SERVICE LETTER / NOTIFICATION – July 28, 2020

Control surface clearances

All aircraft – CH designs

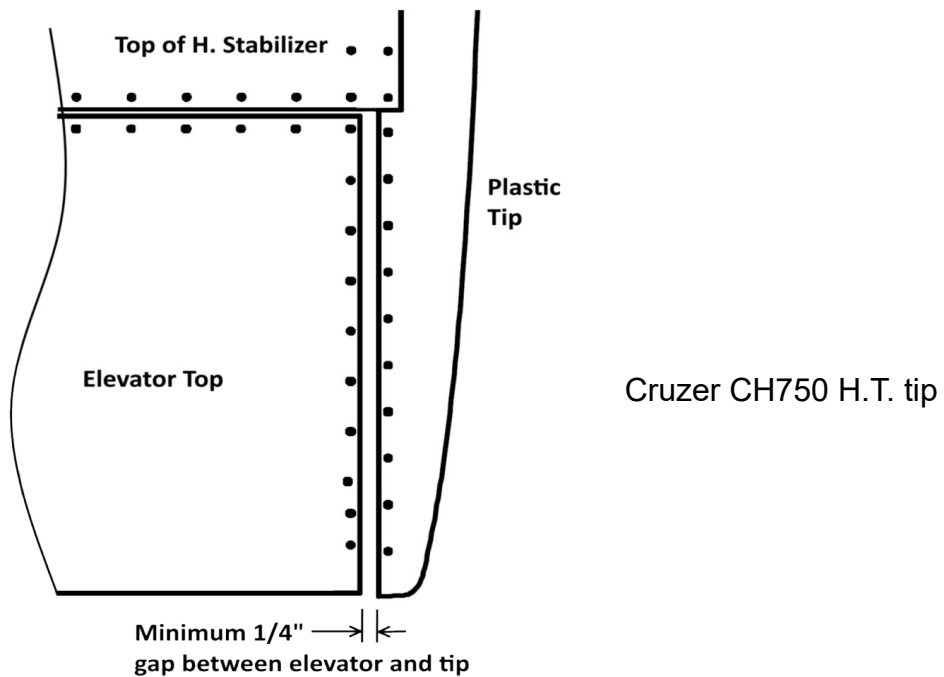
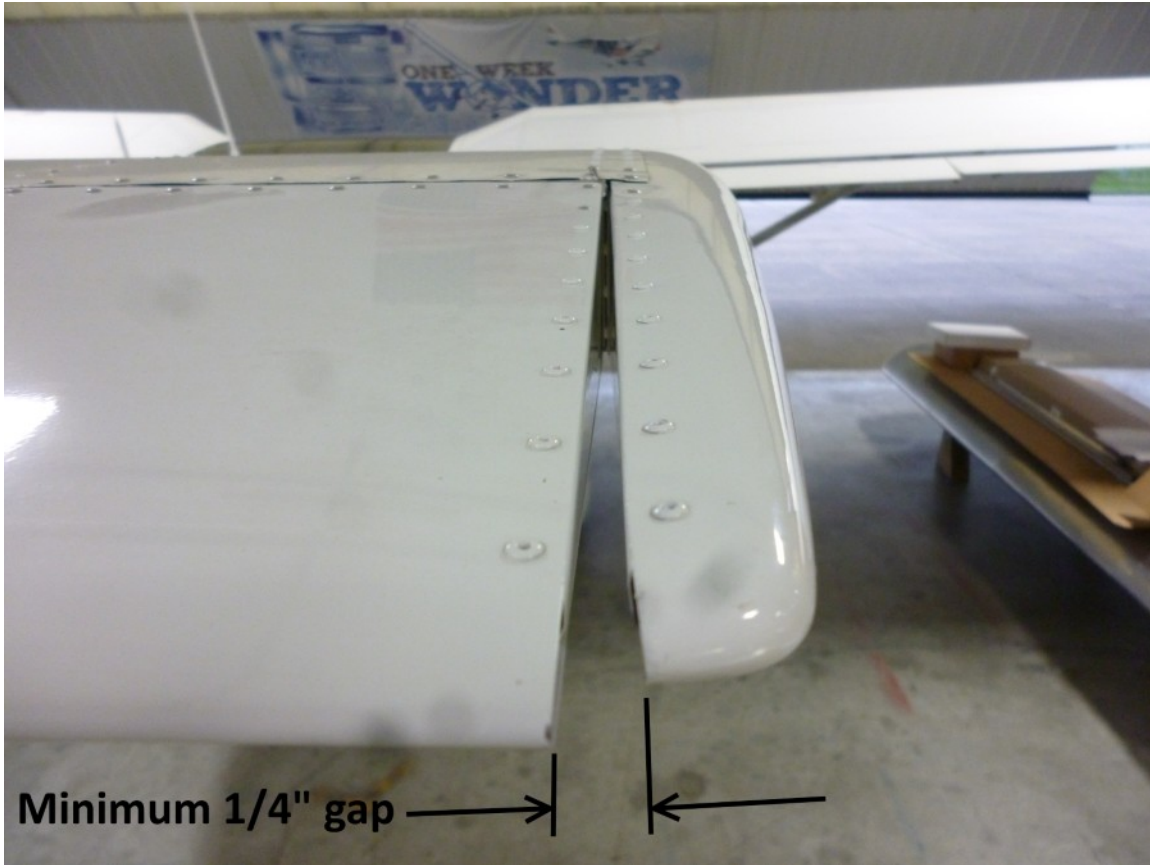
A Zenith Aircraft customer reported that his Cruiser – CH750 elevator was interfering with the tip rib. “I chose to leave a very small gap, and now due to a slight expansion, the plastic tip rib rubs on one side of the elevator. If I would have left a 'normal' size gap, it would be a non-issue”.

Confirm that flight surfaces when deflected move freely, without interference.

“For my fix, I chose to drill out the rivets from the aft edge of the stab back towards the tip. Then I moved the rib over slightly and drilled new holes. Then just trimmed the edge of the plastic tip to make a larger gap”.

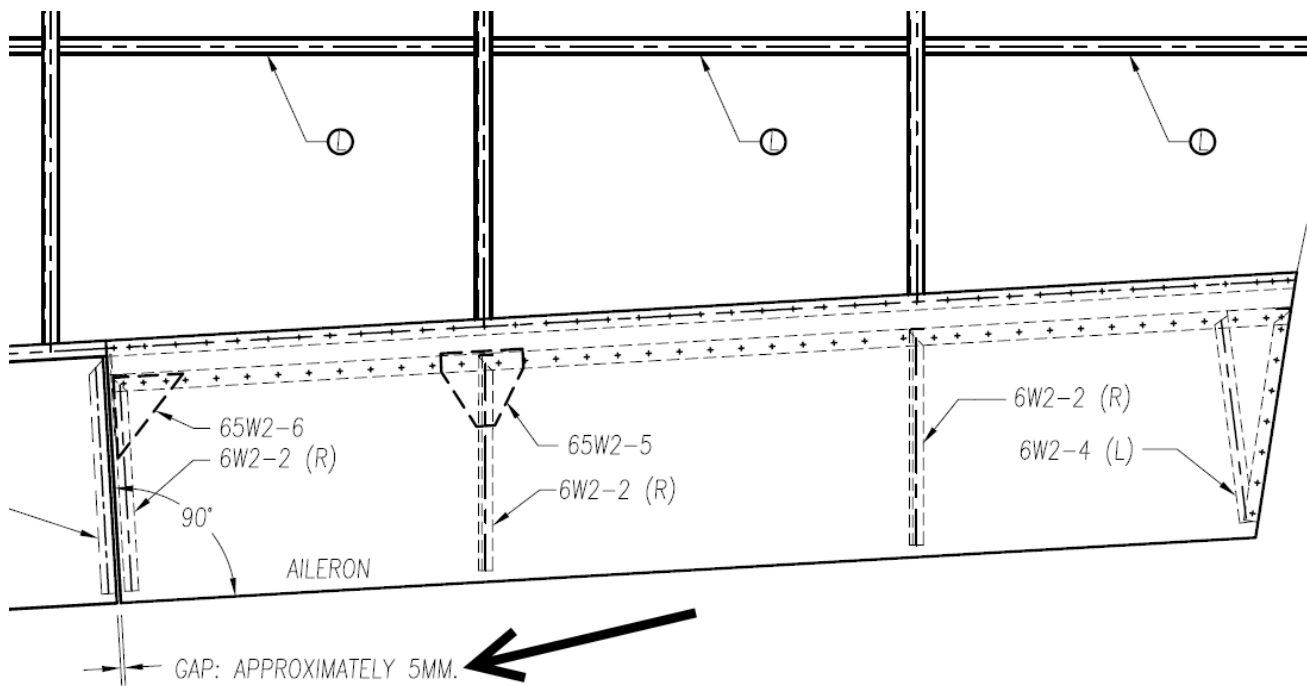
GAP: APPROXIMATELY 5MM. ←
 CHECK: AILERON BOLT DOES NOT TOUCH FLAP.
 IF NECESSARY, MOVE AILERON OUT TO INCREASE GAP TO MAINTAIN SUFFICIENT DISTANCE
 BETWEEN HEAD OF AN5 BOLT THROUGH HORN 6W2-1 AND FLAP: REF. 6-W-10

Above is from the Zodiac 650 drawings. A 5mm gap (about 3/16") is recommended between the aileron and the flap.
